FINAL CLOSEOUT REPORT
100TH STREET STORM SEWER ABANDONMENT AND RELOCATION
OPERABLE UNIT 3

102nd STREET LANDFILL SITE
NIAGARA FALLS, NEW YORK

RE: 102nd Street Landfill Site, Niagara Falls, NY
Final Closeout Report and Remedial Action Report
100th Street Storm Sewer Abandonment and Relocation
Operable Unit 3

Comment 6: Remedial Action Report, Page 11, Section 4.4; Drawing 30K-04C

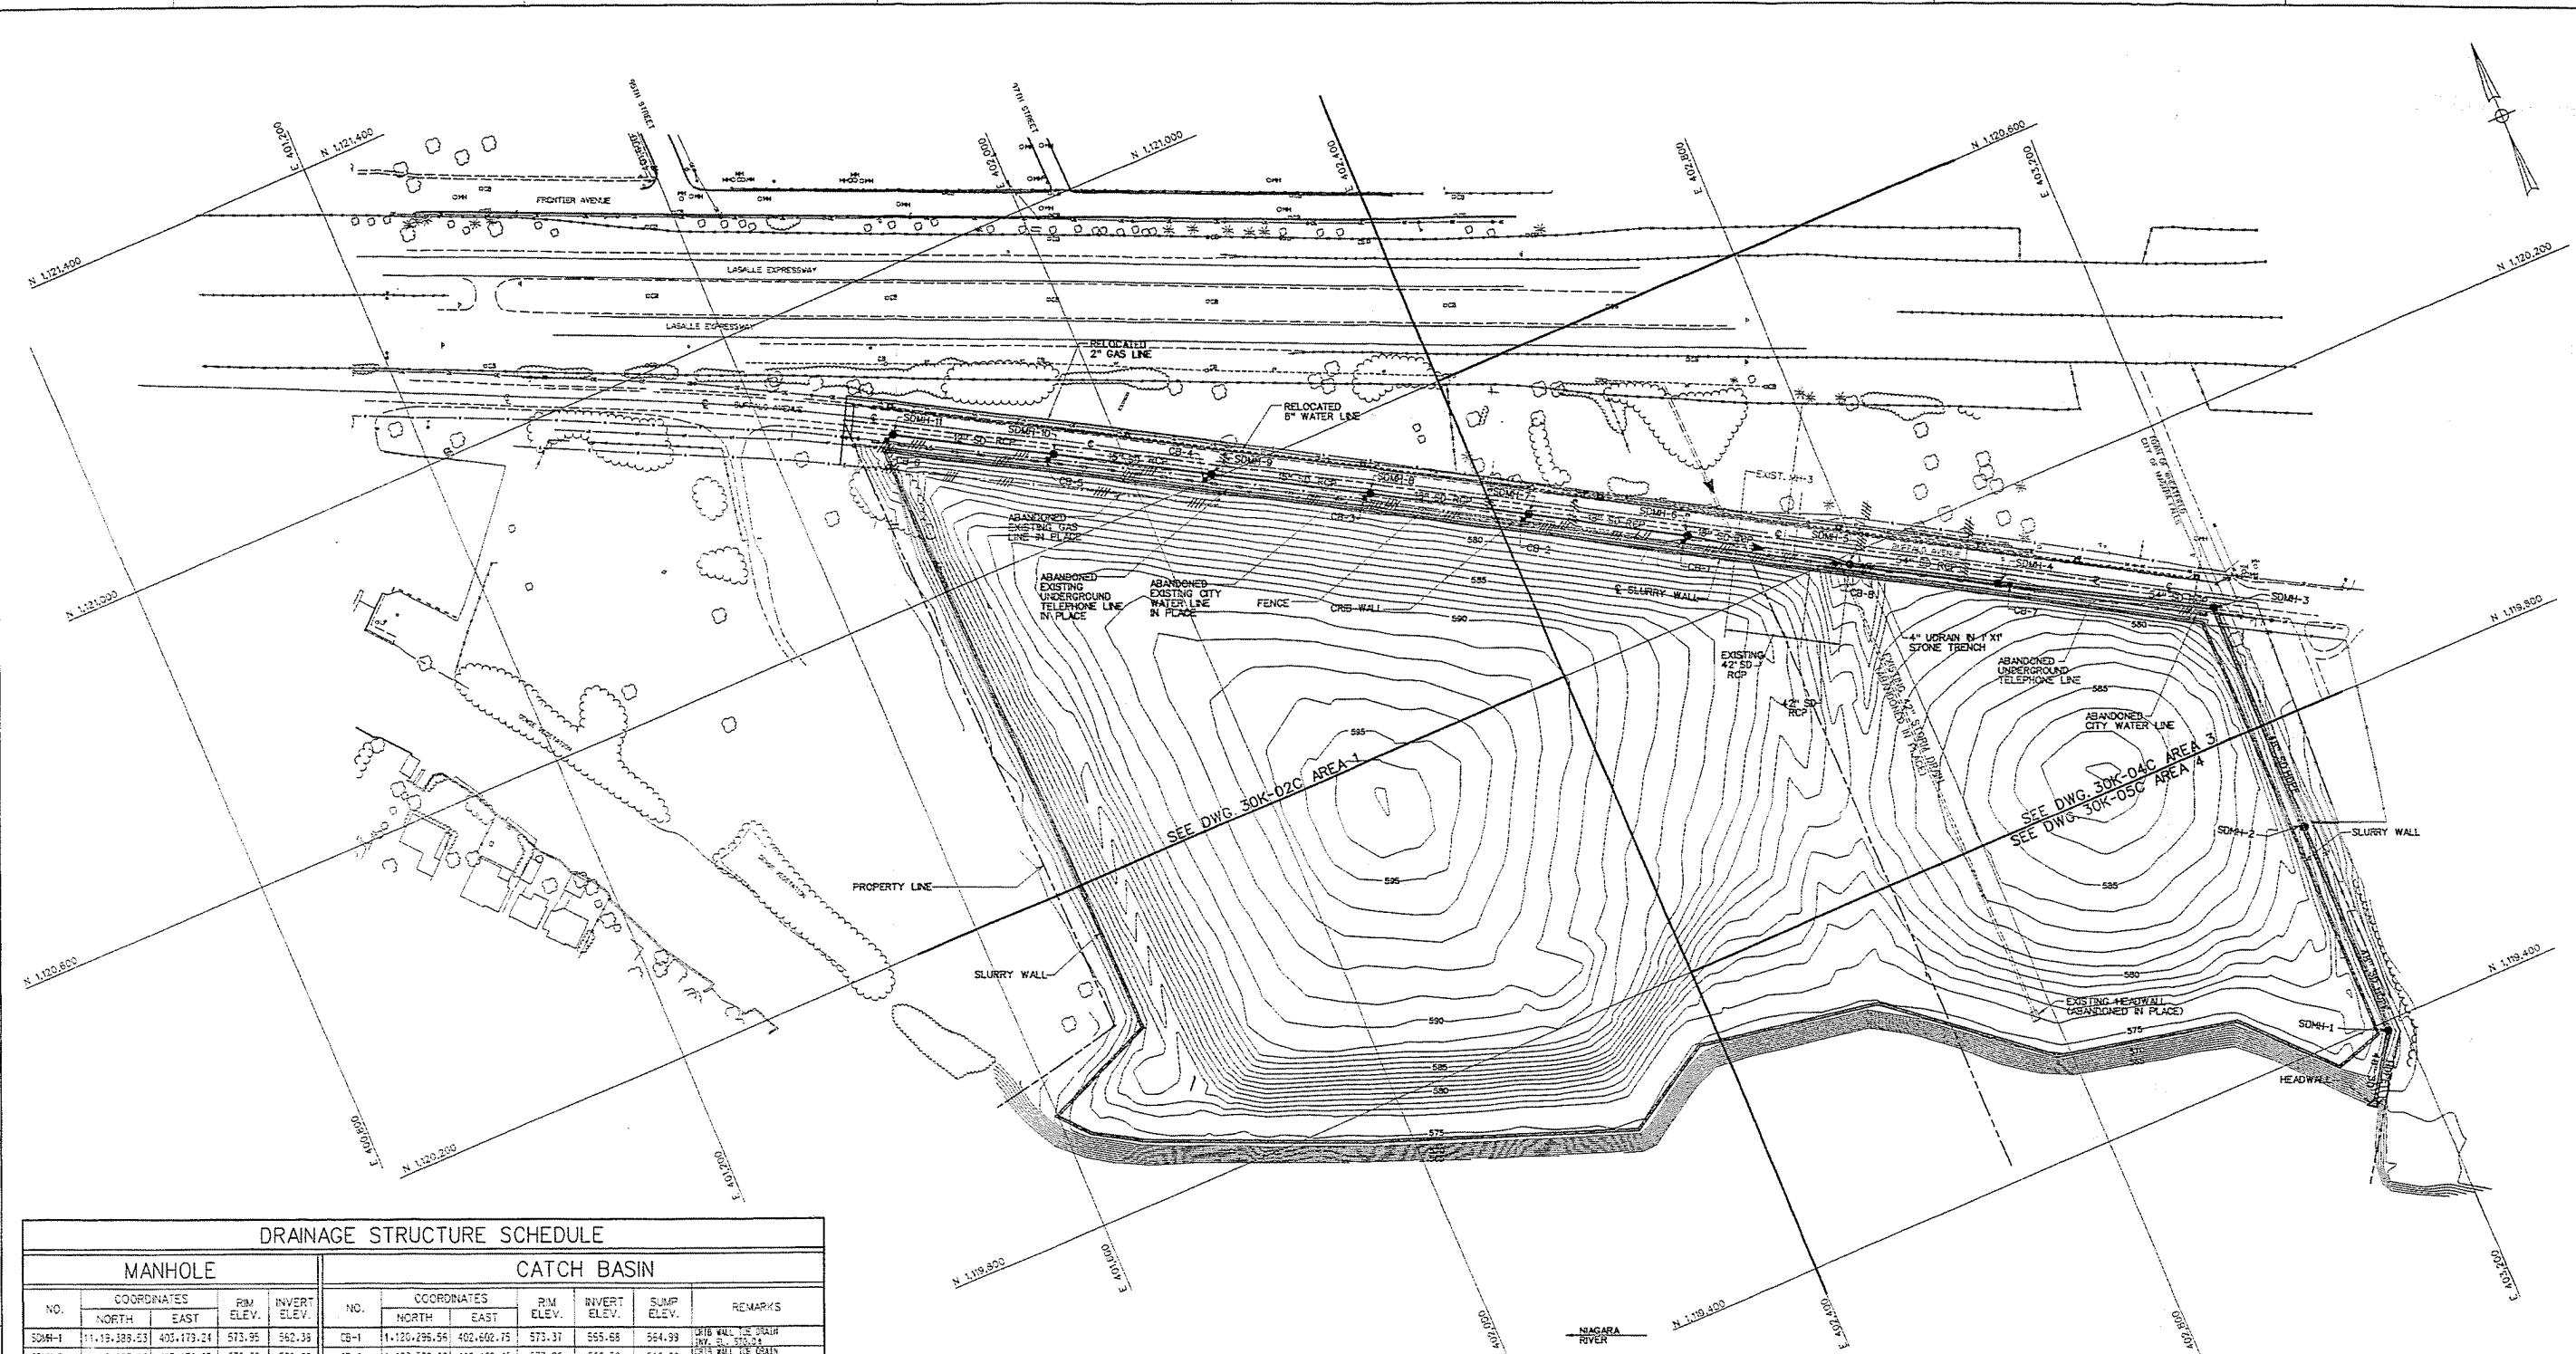
Field change approval dated 8/27/96 states the rim elevation of storm sewer MH-1 was raised to elevation 572.5, but the drainage structure schedule on Drawing 30K-01C shows the rim elevation of MH-1 at 573.95. The Companies shall correct this inconsistency.

Response: The elevations stated in the FCA was a proposed modification. The 573.95 feet elevation reflects as built conditions.

OXYCHEM/OLIN
REMEDIAL DESIGN
102ND STREET LANDFILL SITE
NIAGARA FALLS, NEW YORK
SITE REMEDIATION PLAN AREA 3
STORM DRAINAGE
SCALE: 1"=40'
DATE: 6-22-98
DRAWING NO.: 594000-30K-04C

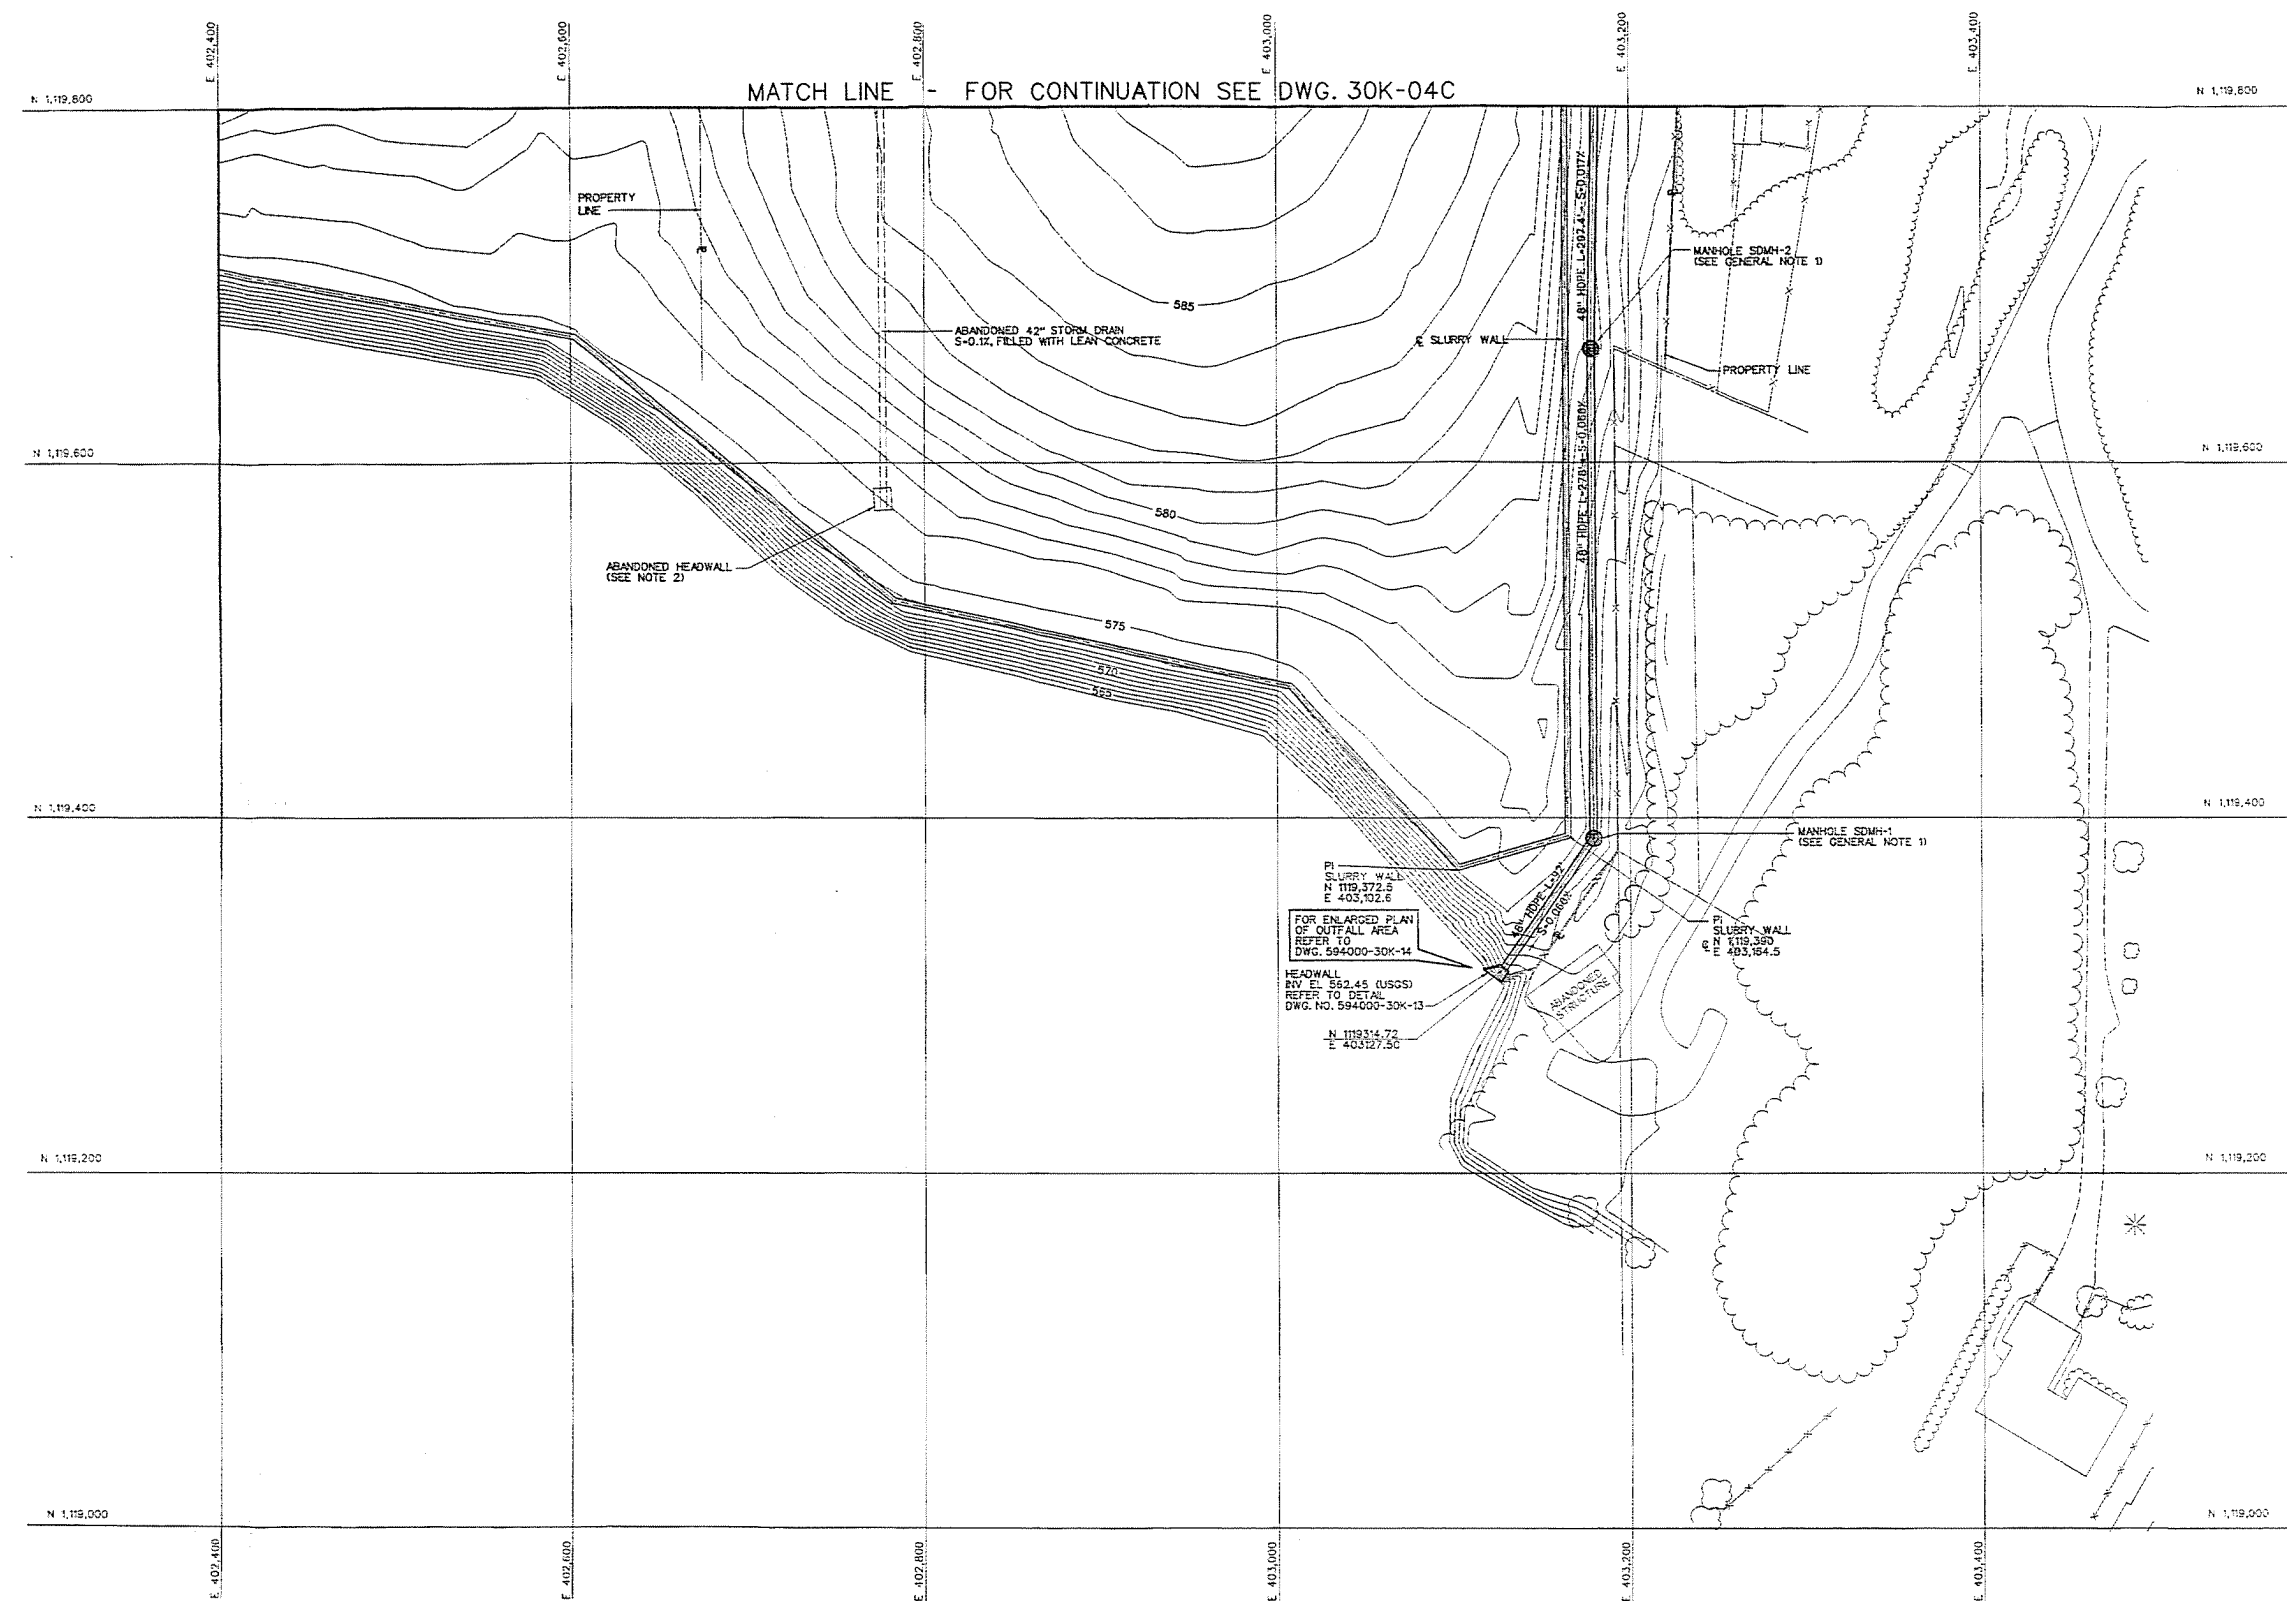
On Page 11, the 3rd paragraph of Section 4.4 states "An approximately 20 foot section of existing 42-inch RCP that ran south from former MH-2..." and Drawing 30K-04C states "Replaced Approx. 15 LF of exist. 42" storm drain and exist. MH-2." The Companies shall Correct these inconsistencies.

Comment 18: *Drawing 30K-04C*

Comment 19: *Drawing 30K-04C*

Comment 20: *Drawing 30K-04C*

Comment 21: *Drawing 30K-04C*

Comment 22: *Drawing 30K-04C*

Comment 23: *Drawing 30K-04C*

Drawing 30K-04C states: Removed approximately 15 LF of existing storm drain and existing MH-2, and Note 7 has been revised as follows: Removed MH-2 and approximately 15 LF of existing 42" RCP that ran south from existing MH-2 and traversed the Site.

Response: This drawing has been revised to show the labels of the tie-ins of the water line and references Notes 1 and 6.

Response: This drawing has been revised to show the labels of the existing water service connections abandoned between SDMH-5 and SDMH-4.

Response: This drawing has been revised to show the labels of the new hydrants.

Response: This drawing has been revised to show the labels of the existing storm drain tie-in to SDMH-4.

Response: This drawing has been revised to show the labels for the catch basins and manholes with reference to General Note 2, not General Note 3.

Response: General Note 2 has been revised.

TYPICAL SECTION
MANHOLES SDMH-2 & 3
(PRECAST CONCRETE)
N.T.S.

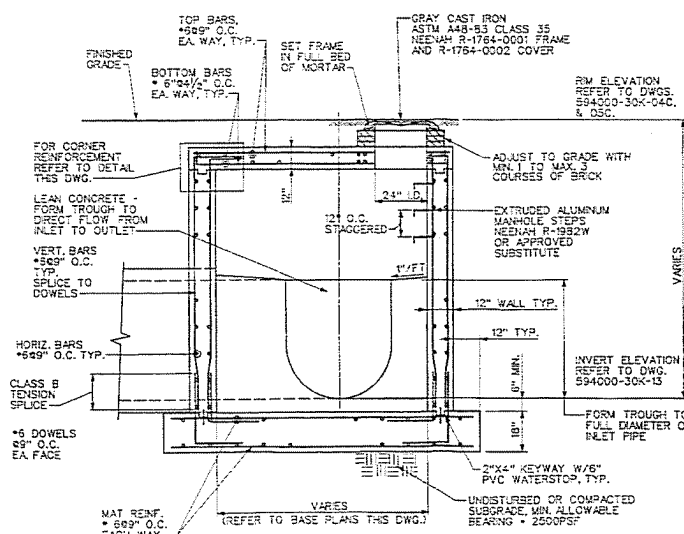
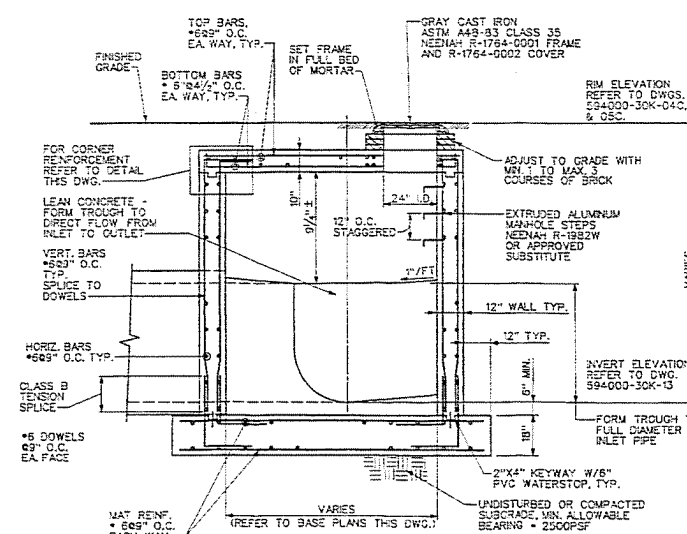
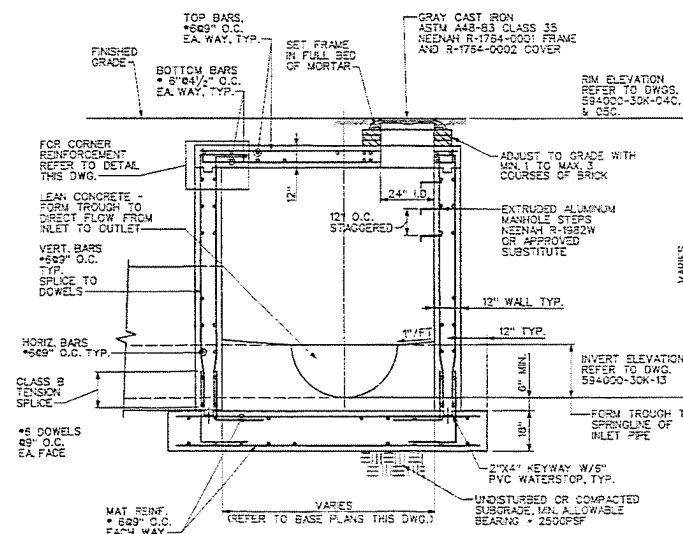
Field change approval dated 8/9/96 states that the formed invert flow channels in SDMH-1, 4 & 5 were modified. Accordingly, the Companies shall change Drawing 30K-14 to show the modified formed invert channels.

Response: Drawing 30K-14 has been revised to show the modified form invert channels.
